Application for Works Approval Amendment

Works Approval Number	W6618/2021/1
Works Approval Holder	Talison Lithium Australia Pty Ltd
ACN	139 401 308
File Number	DER2021/000628~2
Premises	Talison Lithium Mine Maranup Ford Road Part of mine tenements M01/6 and M01/7 As defined by the premises maps in Schedule 1 As defined by the Premises map attached to the Revised Works Approval
Date of Report	27 March 2024
Decision	Revised works approval granted

On 26 October 2023, the works approval holder submitted an application to the department to amend works approval W6618/2021/1 under section 59 and 59B of the *Environmental Protection Act 1986* (EP Act). The proposed amendment is to change the proposed liner for tailings storage facility 4 (TSF4) cell 2 from engineered clay to bituminous geomembrane (BGM). BGM is now the works approval holder's preferred option due to time limitations and weather-related constraints in using engineered clay, as well as challenges sourcing and engineering sufficient suitable clay.

Figure 1 Starter embankment plan at 265 m AHD (black) and future lift to 270 m AHD (pink)

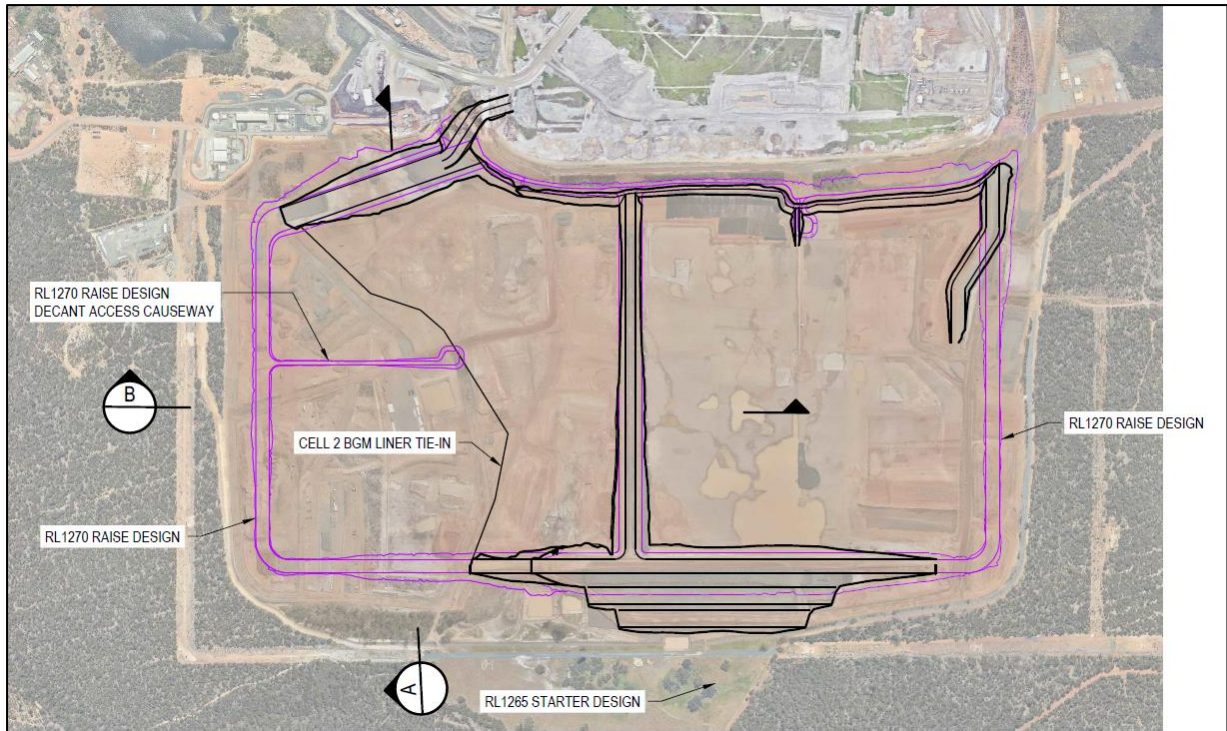
The department noted, per design drawings provided in the application, that the proposed BGM liner will only cover the eastern portion of TSF4 Cell 2 from the northern and dividing embankments to the 265 m AHD (RL 1265m) contour that runs north to south through the center of the cell (see Figure 14 in the amended works approval). Following clarification from the works approval holder that Cell 2 will be built in two-stages, it is understood the eastern side of this contour (elevation less than 265 m AHD) will be lined with BGM and receive tailings during the initial operation of the cell (stage 1) up to 264.7 m AHD. This is the section of Cell 2 under assessment in this report.

The works approval holder has proposed no modifications to the authorised location of tailings pipelines, decant structure and decant pipelines servicing TSF4 Cell 2 to enable the management of tailings discharge into the eastern portion of Cell 2. The western portion in Cell 2 with elevation above 265 m AHD will be levelled and lined with BGM under a separate works approval to raise Cell 2 to 270 m AHD (stage 2). Figure 1 shows the extent of the initial starter embankments to be built to 265 m AHD under this works approval.

Figure 3 Sensitive receptors downstream of TSF4

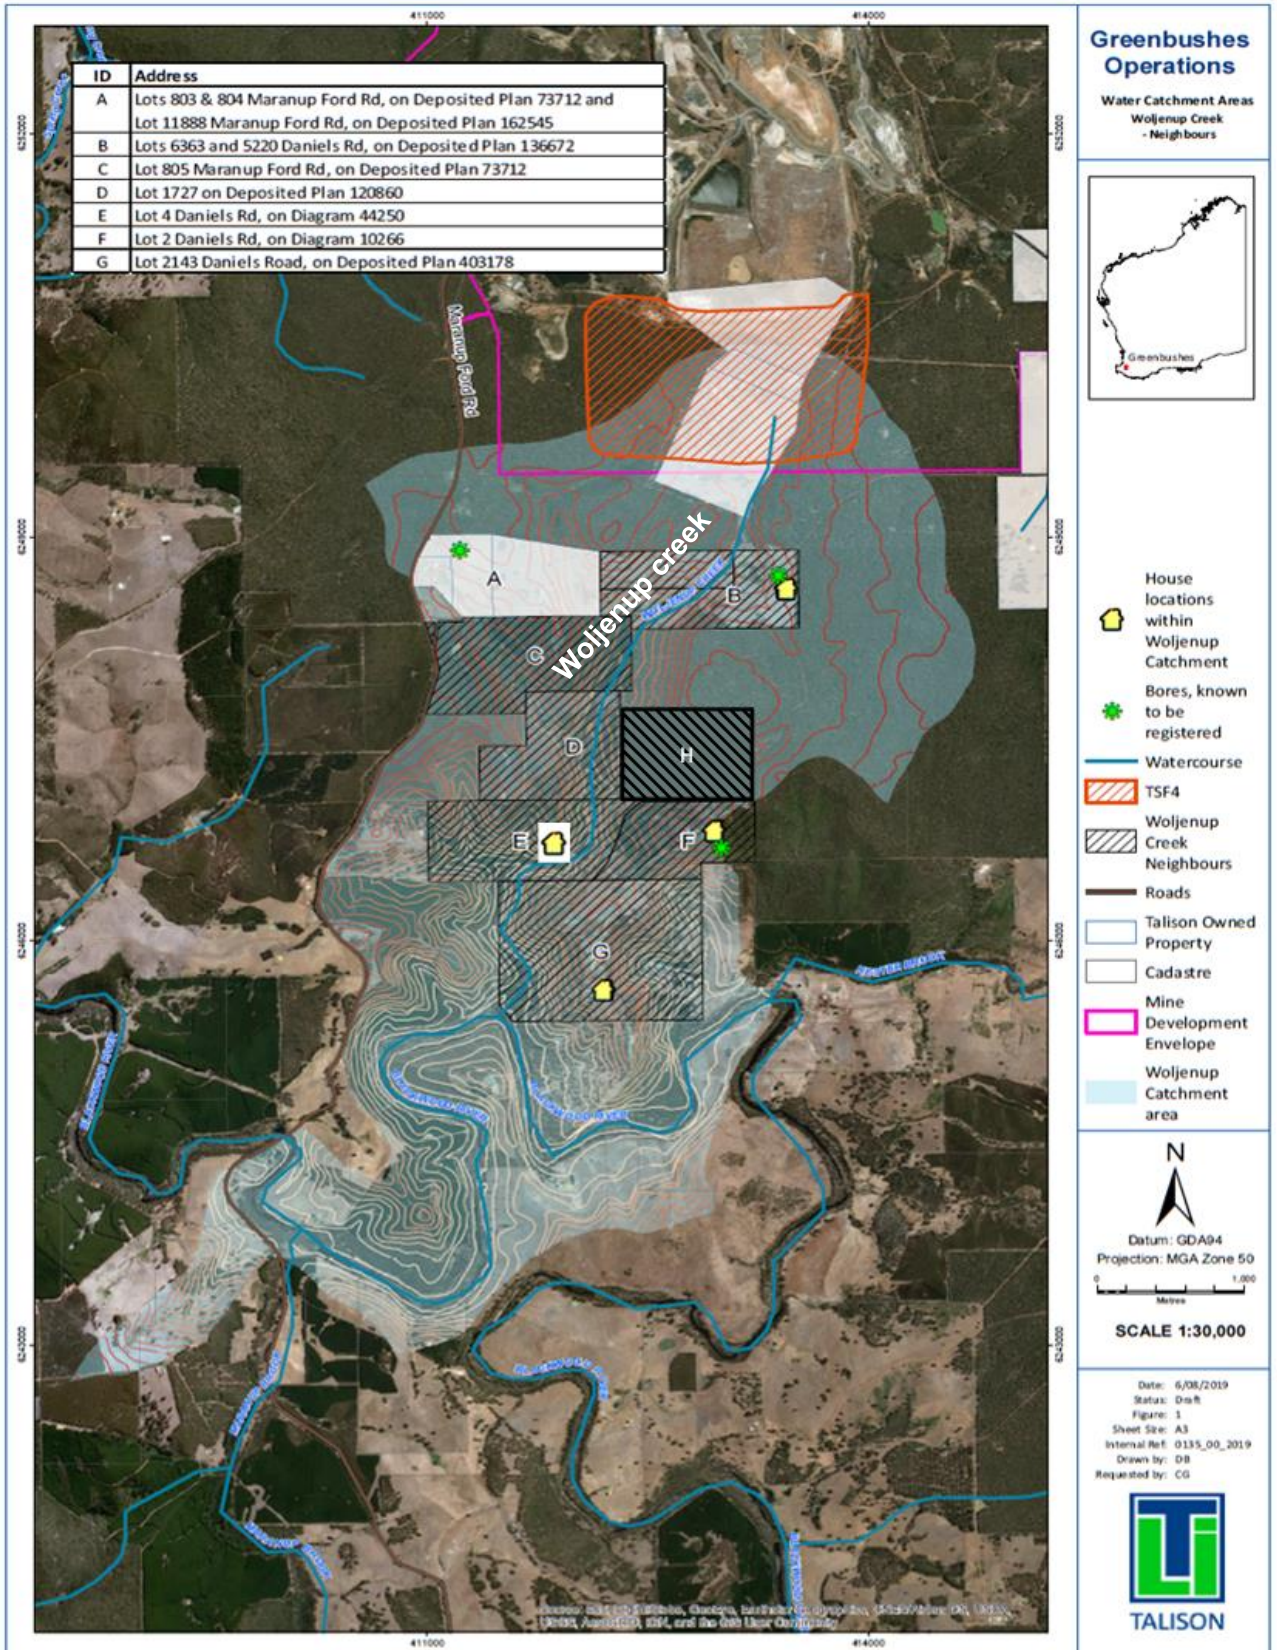
Environmental receptors	Distance from prescribed activity
<p>Blackwood River and tributaries, including Woljenup creek</p>	<p>Woljenup creek is immediately south and down-gradient of TSF4 (Figure 3)</p>
<p>Cowan Brook, Norilup Dam and Norilup Brook (water quality and ecology)</p>	<p>At the western edge of the premises boundary (offsite).</p> <p>Seepage from Cowan Brook Dam flows into Cowan Brook and into Norilup dam.</p>
<p>Nearby native vegetation</p>	<p>Immediately adjacent to TSF4</p>
<p><u>DBCA Legislated Tenure</u> Greenbushes State Forest</p>	<p>A proposal for expansion activities (including TSF4) was approved under Part IV of the Act for which Ministerial Statement MS 1111 was granted on 19 August 2019.</p> <p>Receptors addressed under ministerial statement MS</p>
